**TOWN OF NEWBURGH
PLANNING BOARD
TECHNICAL REVIEW COMMENTS**

PROJECT NAME: LZL EQUITIES INC. (DUNKIN DONUTS)
PROJECT NO.: 14-02
PROJECT LOCATION: SECTION 14, BLOCK. 1, LOT 43
REVIEW DATE: 30 NOVEMBER 2015
MEETING DATE: 3 DECEMBER 2015
REPRESENTATIVE: MERCURIO NORTON TAROLLI MARSHALL

Re: Job No. 3950
Lands of O'Connor
Tax Map Parcel: 14-1-43
NYS Route 300 & NYS Route 32
Town of Newburgh
Dunkin Donuts Site Plan
Town of Newburgh Project #2014-02

The following changes have been made to the plans and report to address the Town of Newburgh Planning Board Engineer's September 25, 2015 comment letter:

Site Plan for LZL Equities, LLC

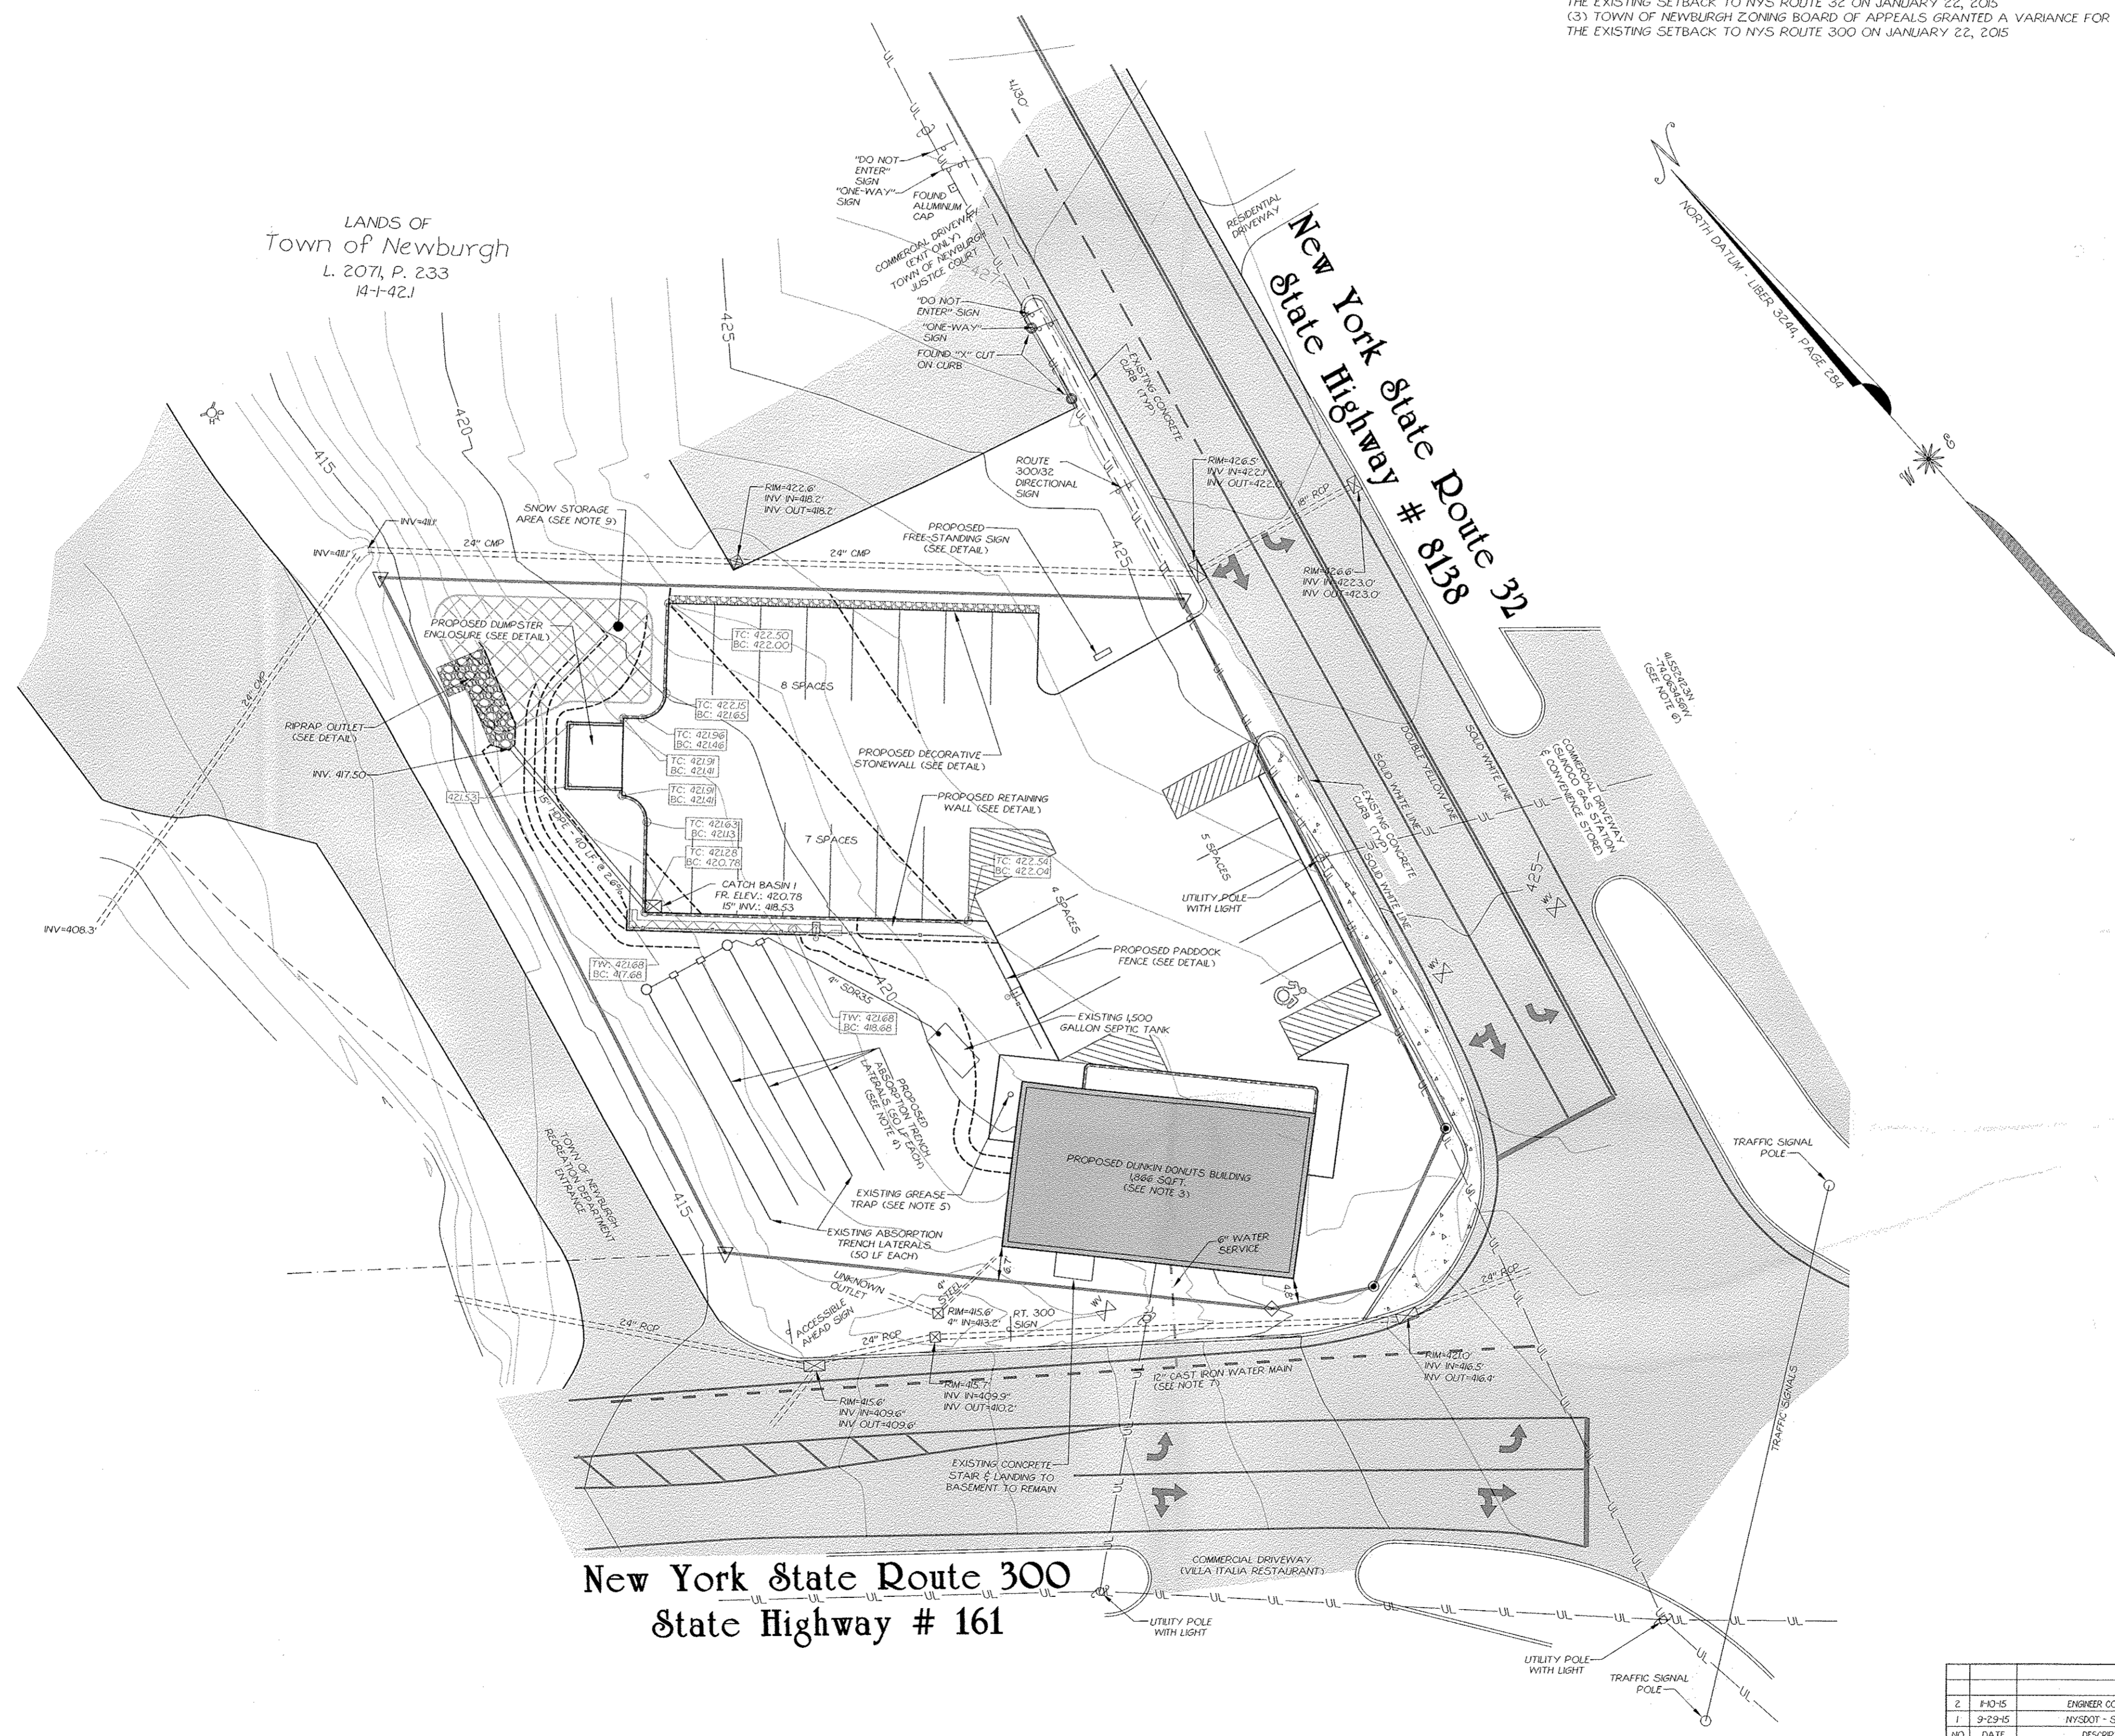
The Department has further considered all vehicle movements at the site access. At this time, full access will be allowed with the stipulation that if operational difficulties arise, a turn restriction(s) will be imposed. Operational difficulties would include an increase in crashes related to the turn movements and/or queuing of Route 32 northbound traffic back to the intersection. Understand that any turn prohibition enacted would be in effect for 24 hours. Please include appropriate verbiage to this effect on the plan sheet.

2. A snow storage area has been indicated on the plans. Note 9 has been added to sheet 1 of the plan set indicating that if the snow accumulation exceeds the available storage of the snow storage area the snow must be removed from the site and not allowed to accumulate in the parking lot.

- NEW YORK STATE DEPARTMENT OF TRANSPORTATION (NYSDOT) WILL ALLOW THE EXISTING ENTRANCE TO BE USED WITH FULL ACCESS. IF OPERATIONAL DIFFICULTIES ARISE, NYSDOT WILL IMPOSE TURN RESTRICTIONS ON THE ENTRANCE. OPERATIONAL DIFFICULTIES WOULD INCLUDE AN INCREASE IN CRASHES RELATED TO THE TURN MOVEMENTS AND/OR QUEUING OF ROUTE 32 NORTHBOUND TRAFFIC BACK TO THE INTERSECTION. ANY TURN PROHIBITION ENACTED WOULD BE IN EFFECT FOR 24 HOURS.

- SNOW SHALL BE STORED WITHIN DESIGNATED SNOW STORAGE AREA. IF SNOW ACCUMULATION EXCEEDS THE CAPACITY OF THE DESIGNATED STORAGE AREA, THE SNOW SHALL BE REMOVED FROM THE SITE. SNOW SHALL NOT BE PERMITTED TO BE STORED IN ANY PARKING AREA.

Landscape Plan for LZI Equities, LLC

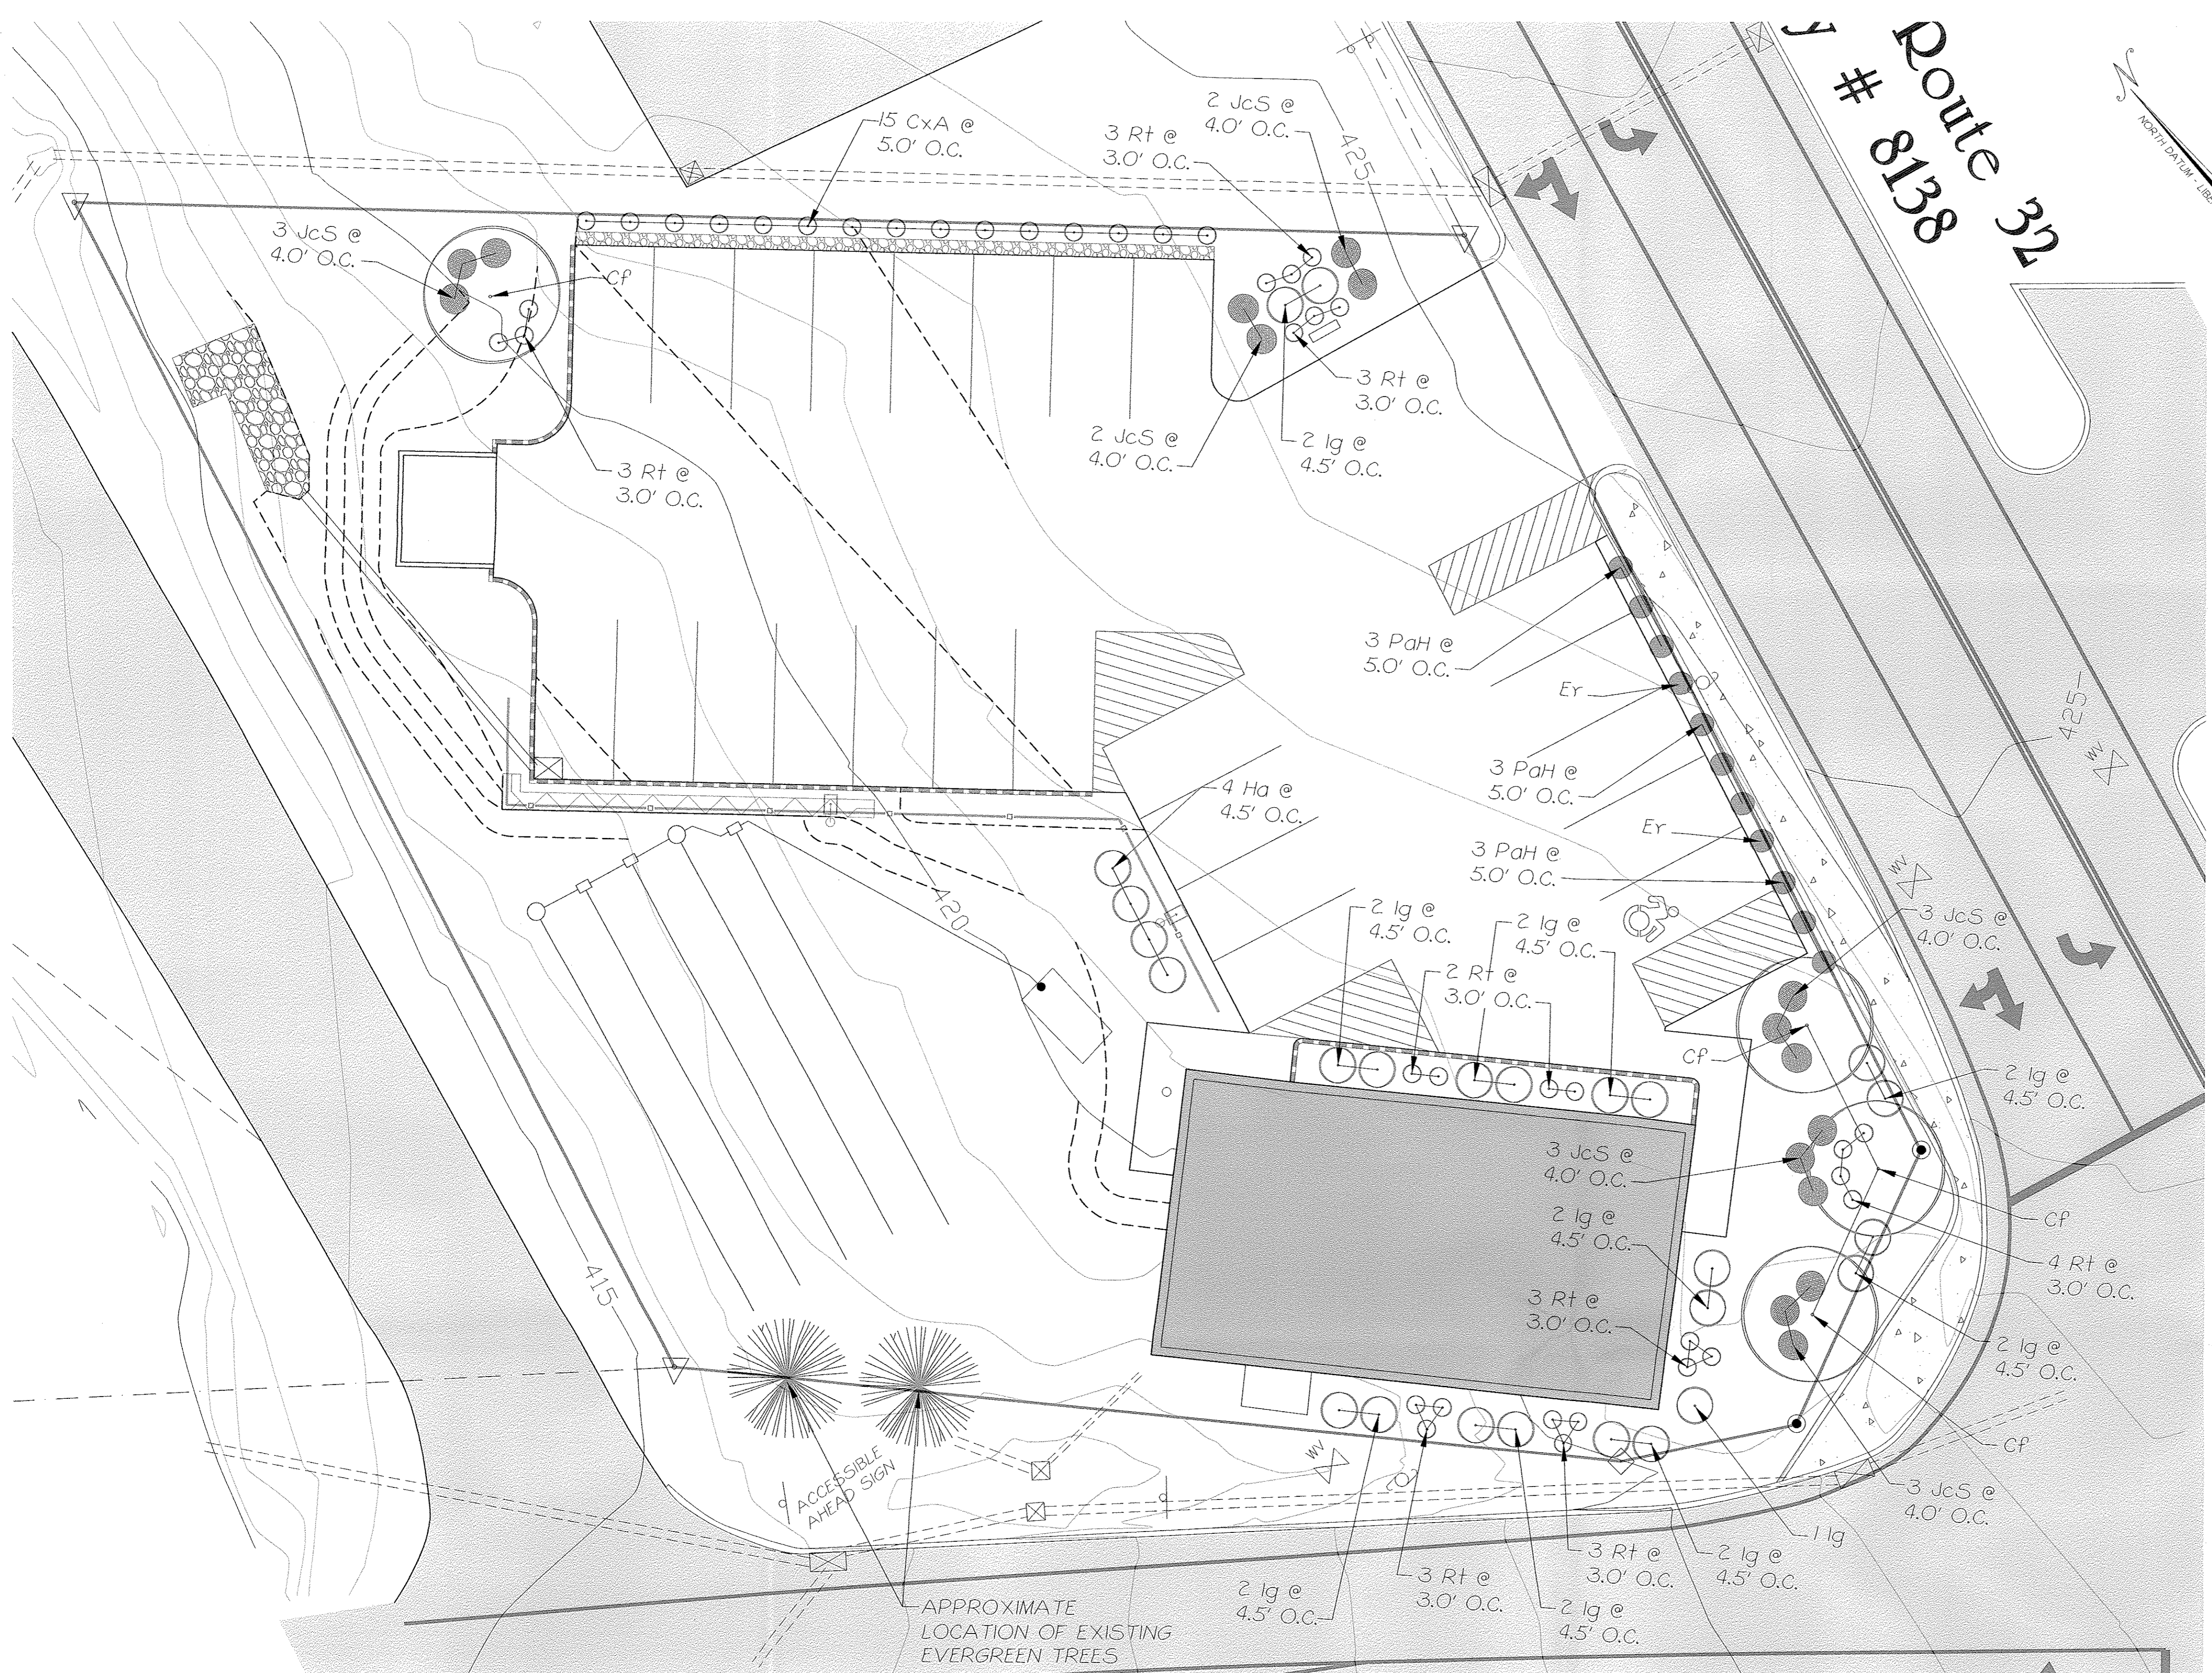
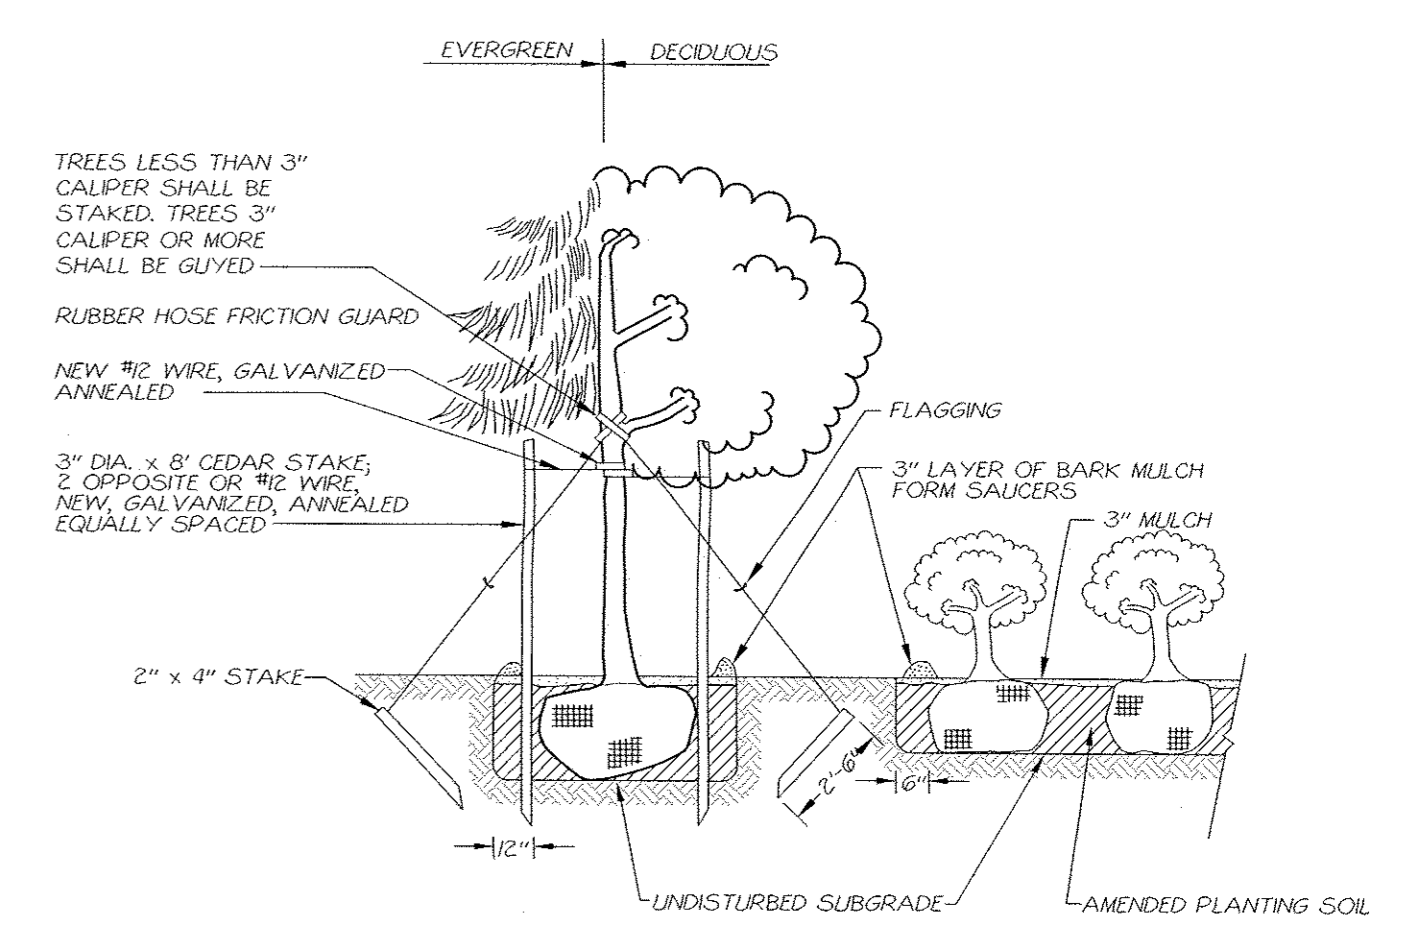
1. The landscaping plans have been changed per NYS DOT requirements. Stone walls have been eliminated from the right of way based on the NYS DOT requirements. Planning Board should review revised landscaping plan for acceptability .
2. A portion of the stone wall has been retained between the Town Court facility and the Parking area. Pedestrian access between the facilities has not been prevented.
3. NYS DOT has stated that full turning movement will be granted at the subject site with a condition that future restrictions may be imposed .Note eight has been added to the plans as per DOT 's request.
4. Snow storage area has been depicted in the North West portion of the site.
5. Revised sub surface sanitary sewer disposal system is acceptable.

8. The landscaping plan has been revised to address the NYSDOT requirements to remove the previously proposed stone walls within the "clear zone" (30 feet from the white line). Due to the requirement to remove the stone walls, a series of ornamental grasses have been proposed in place of the main stone wall along the eastern edge of the parking lot. In addition, the landscaping on the northern and southern edges of said parking has been supplemented with additional plantings.

has been removed and replaced with a series of ornamental grasses. Ornamental grasses have been selected for this area due to the proximity of the landscaping to paved areas, the hardiness of grasses to survive through the winter. The landscaped areas on either side of the parking lot have also been supplemented to include additional landscaping.
